RBG-45950

SUBJECT: River Bend Station, Unit 1  
Docket No. 50-458  
License Amendment Request  
LAR 2002-17, River Bend Nuclear Station Proposed Amendment of  
Facility Operating License to Remove Operating Mode Restrictions for  
Performing Emergency Diesel Generator Testing

**Analysis of Proposed Technical Specification Change**

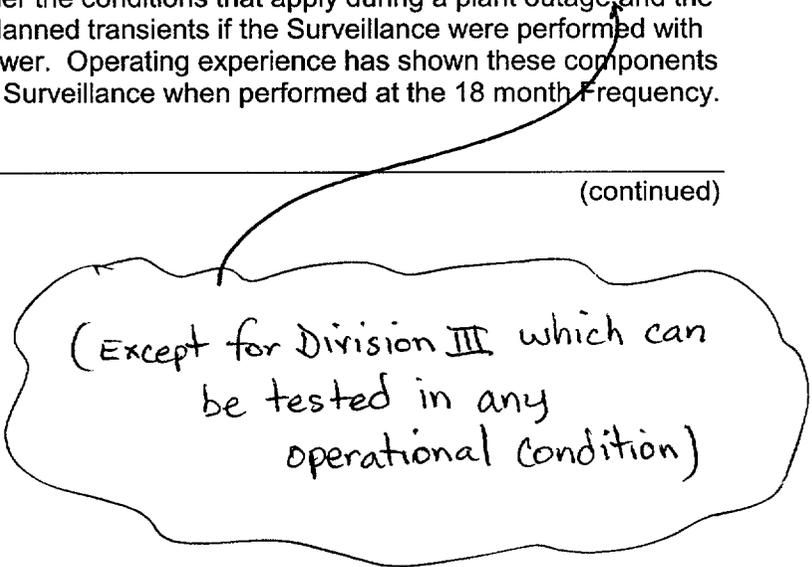
(Except for Division III which can be tested in any operational condition)

SR 3.8.1.11 (continued)

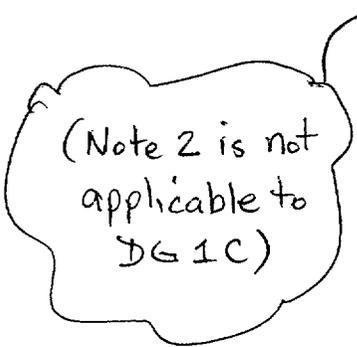
(Note 2 is not applicable to DG 1C)
